Groundwater Transfer Review Summary Form

Transfer/PA # T- 14156

Application: T-14156

Applicant Name: City of Prineville

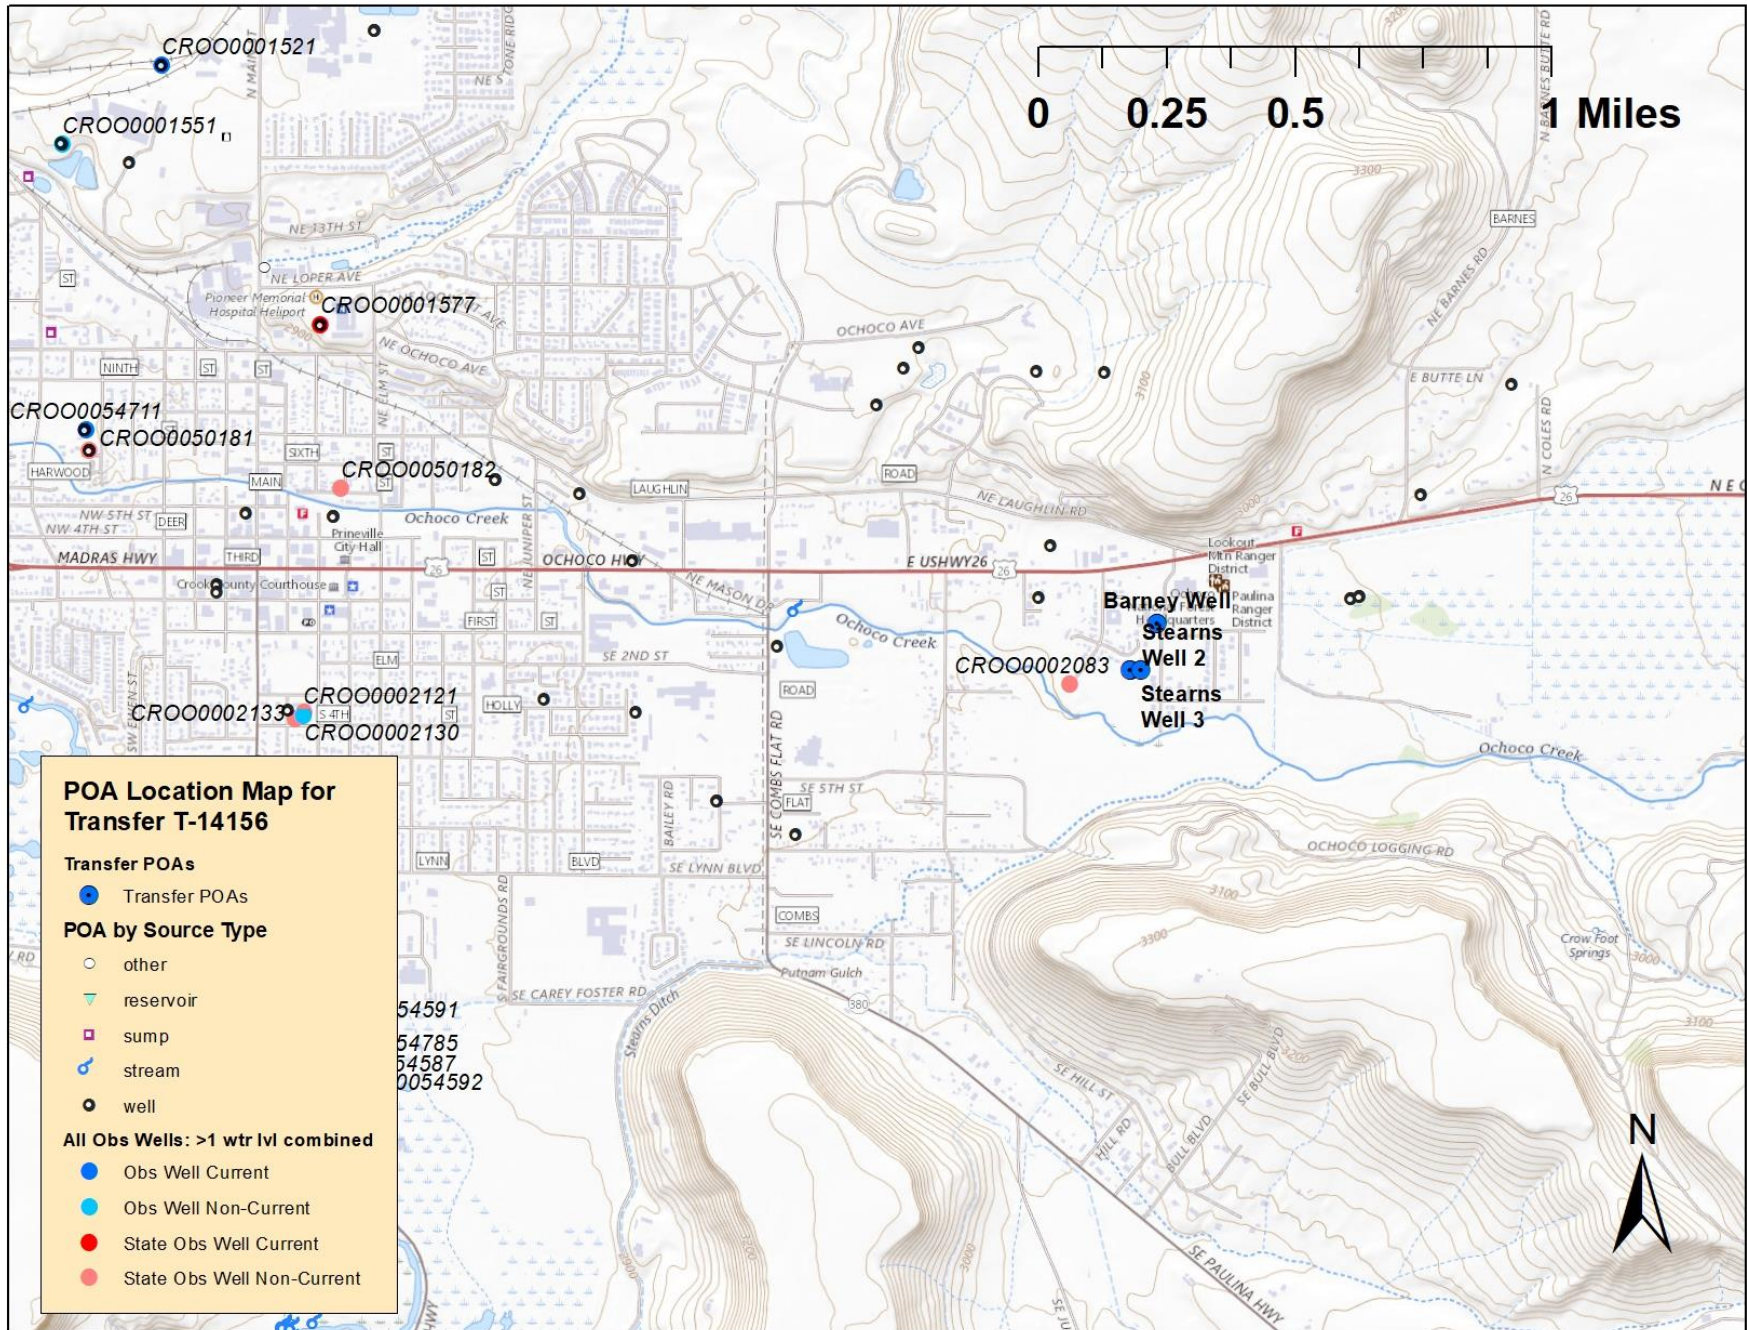
1. Basic description of the changes proposed in this transfer: The originating certificate 94816 authorizes 1.35 cfs of municipal use from two wells (CROO 2083 aka Stearns Well 2 & CROO 3132 aka Barney Well). This transfer proposes to add an unconstructed APOA (Stearns Well 3) to this water right. Well specific details are included in the table below.

2. Will the proposed POA develop the same aquifer (source) as the existing authorized POA?
 Yes No Comments: The valid POAs access the aquifer hosted within a 10-30-foot-thick package of Pleistocene-aged, coarse-grained alluvium that was deposited by a paleo channel before being buried beneath ~200 feet of fine-grained lacustrine sediment that was likely deposited after basalt flows from Newberry Caldera temporarily dammed the Crooked River. The transfer application proposes construction for Stearns Well 3 to be cased and sealed to 225 feet with an open interval from 225 to 250 feet, which should ensure that the APOA accesses the same source aquifer as the current POAs.

4. a) Will this proposed change, at its maximum allowed rate of use, likely result in an increase in interference with **another ground water right**?
 Yes No Comments: CROO 58 and CROO 59 (~2300 feet east) are the closest groundwater users in the target aquifer. Depending on how the applicant's wells are utilized, the changes may move groundwater production slightly closer to those groundwater users. Adjacent households are either supplied by City of Prineville water or use shallow domestic wells that do not access the target aquifer.

- b) If yes, would this proposed change, at its maximum allowed rate of use, likely result in another groundwater right not receiving the water to which it is legally entitled?
 Yes No If yes, explain: The proposed changes could shift groundwater production from 2350 to 2250 feet from CROO 58. Any resulting changes in interference are unlikely to reach the threshold of substantial or undue interference.

5. a) Will this proposed change, at its maximum allowed rate of use, likely result in an increase in interference with **another surface water source**?
 Yes No Comments: The target aquifer is largely buffered from acute stream depletion by the laterally extensive overlying fluviolacustrine sediments. The aquifer may discharge to Crooked River further downstream, but the 100-foot location change in groundwater production would have negligible changes to stream depletion.

Note: CROO 2083 & CROO 3132 have a well specific limit of 0.81 cfs under certificate 94816. The proposed APOA should also be limited to 0.81 cfs.
